United States Patent and Trademark Office

| APPLICATION NO. | FI | ILING DATE | FIRST NAMED INVENTOR | ATTORNEY DOCKET NO. | CONFIRMATION NO. | |
|-------------------------------------------------------|--------|--------------|------------------------|---------------------|------------------|--|
| 09/674,600 | | 12/13/2000 | Lorenz Camenzind | P/543-103 | 1539 | |

DETAILED ACTION

attacument # 1 (08/21/06)

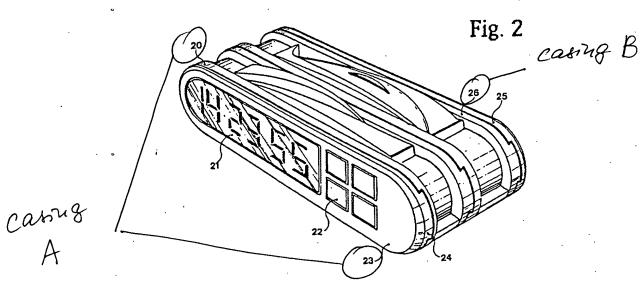
For claim 79: Schaub discloses in Fig. 2 a casing A (comprising a structure 23 and a structure 20). When the device is expanded, the display and measuring device is arranged/ mounted directly onto the internal surface of the casing A.

For claim 80: Schaub discloses in Fig. 2 a casing A (comprising a structure 23 integral with a cover 20) and casing B (structure 26). Thus, the cover 20 is an internal surface of the structure 23/ casing A. The knife is disposed within the casing A and B and, thus, within the cover plate 20. The display and measuring device, and a plurality of additional tools (modules) are located within the casing A and B. When the device is expanded, the display and measuring device is arranged/ mounted directly onto the internal surface of the casing A, which is the internal surface is a cover 20, as shown in Fig. 2. (The numerals A-B have been added by the Examiner, see attachment # 1 to the Office Action)
